ADDENDUM # 5 Bid 20C6, Waverly Elementary School - New Construction

ADDENDUM NO. 5

RE: **WAVERLEY ELEMENTARY SCHOOL REPLACEMENT**

This addendum forms a part of the Contract Documents and modifies the original Bidding Documents dated March 16, 2020. Acknowledge receipt of this Addendum in the space provided on the Form of Proposal.

Job No.	C018.0159.00	Drawn
Scale	As indicated	SAP Checked
Date	03/16/2020	BLP Approved
Drawing Title	ROOF FRAMING PLAN - AREA C	Drawing Number
Sheet	S1.14	Of

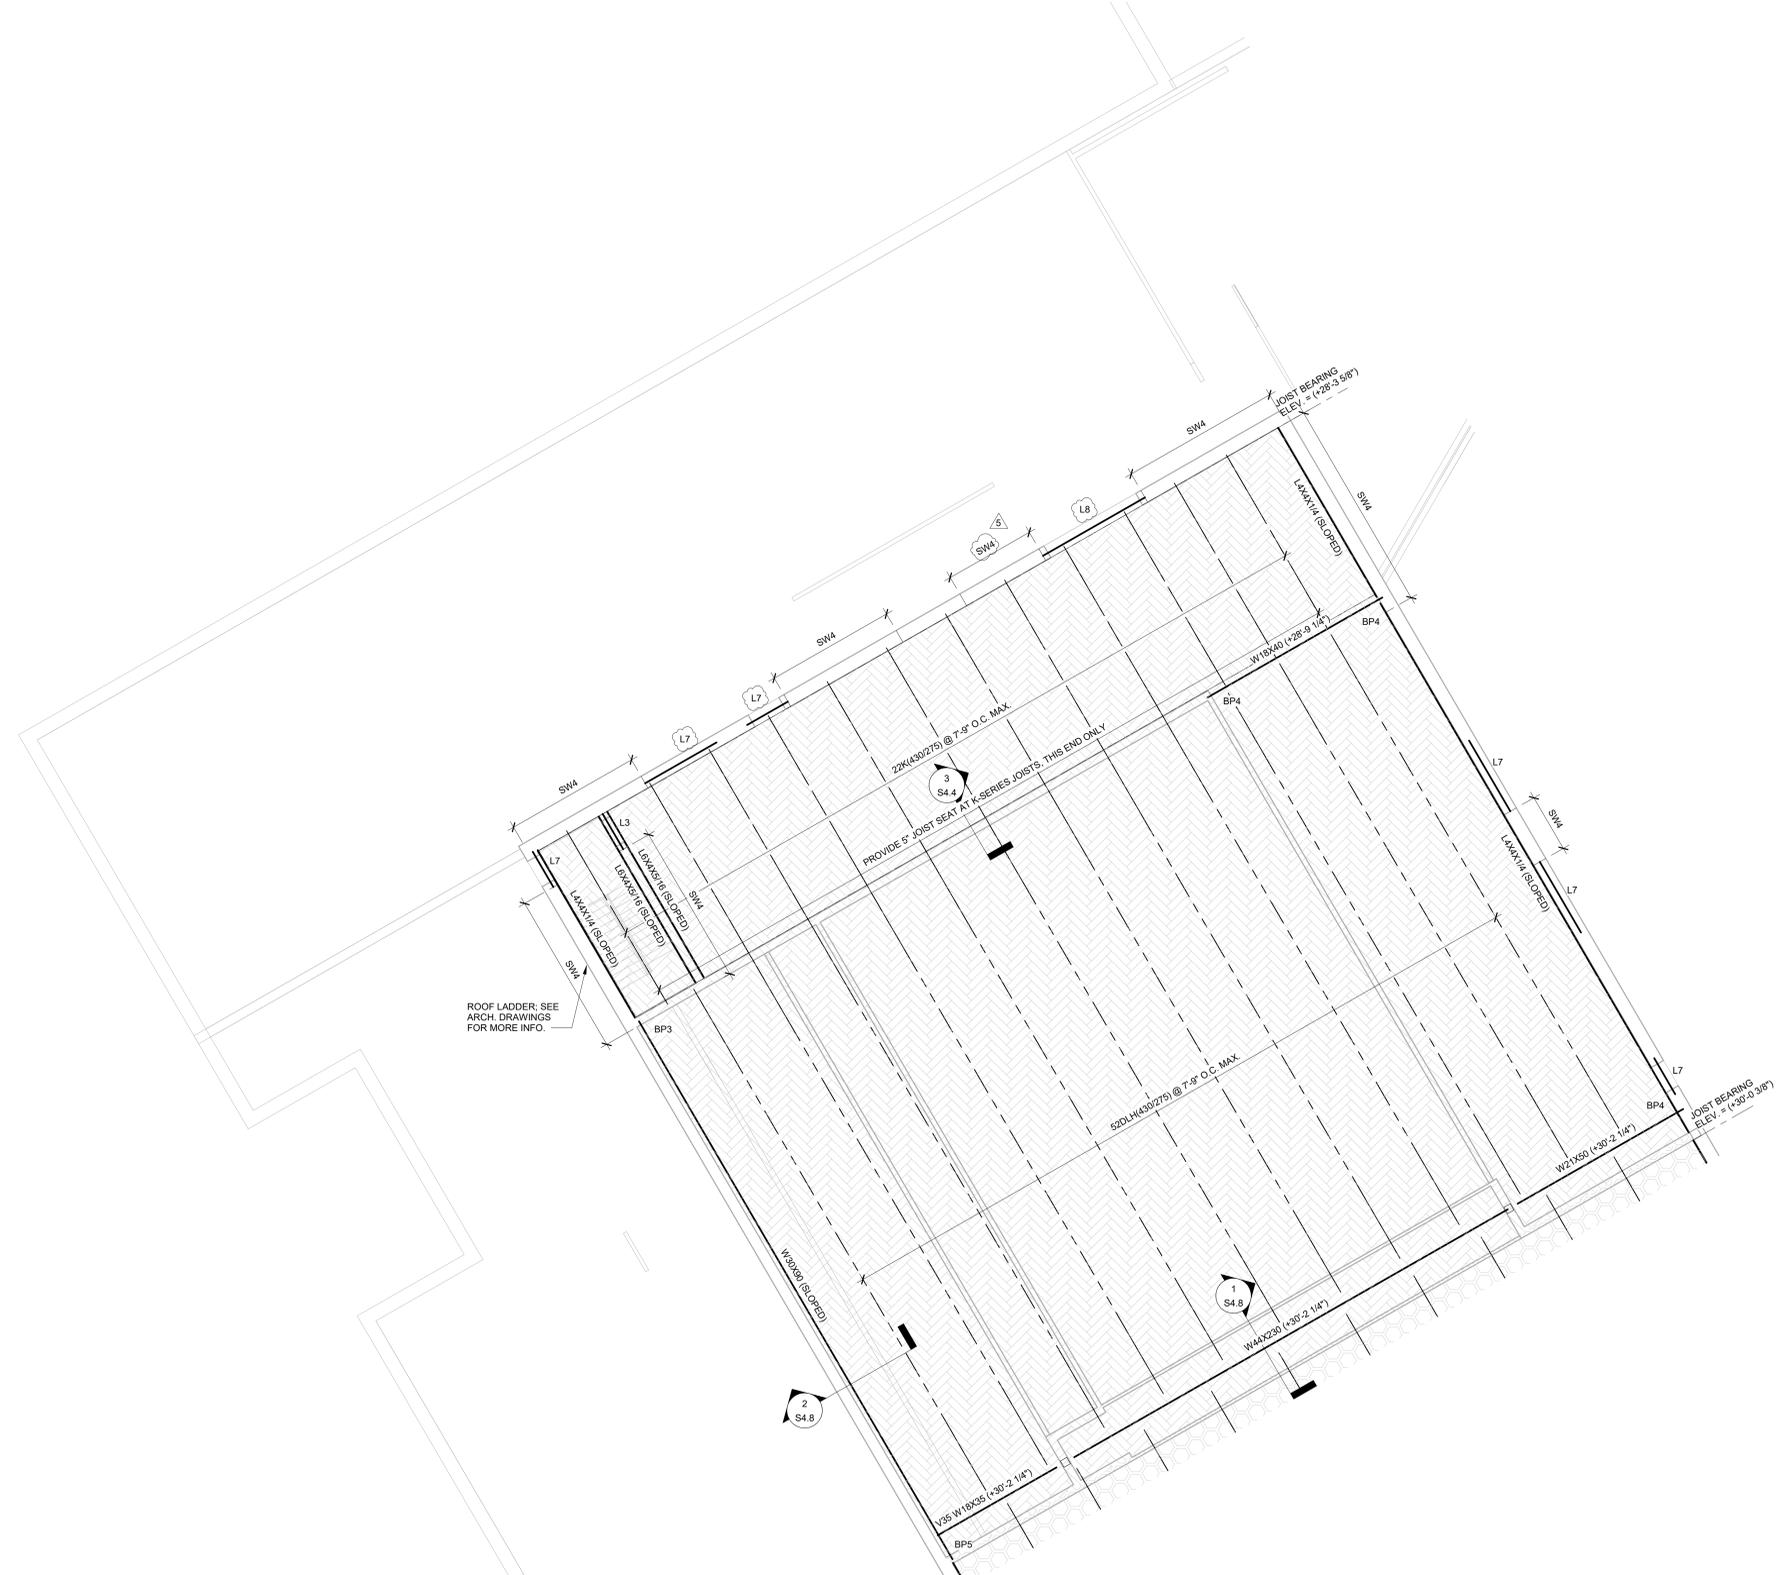
8. **DELETE** Drawing Sheet S1.14 – ROOF FRAMING PLAN – AREA C; Issued for Bid, dated 03/06/2020; **ADD** Drawing Sheet S1.14 – ROOF FRAMING PLAN – AREA C; ADDENDUM #5, (Revision dated 04/15/2020).
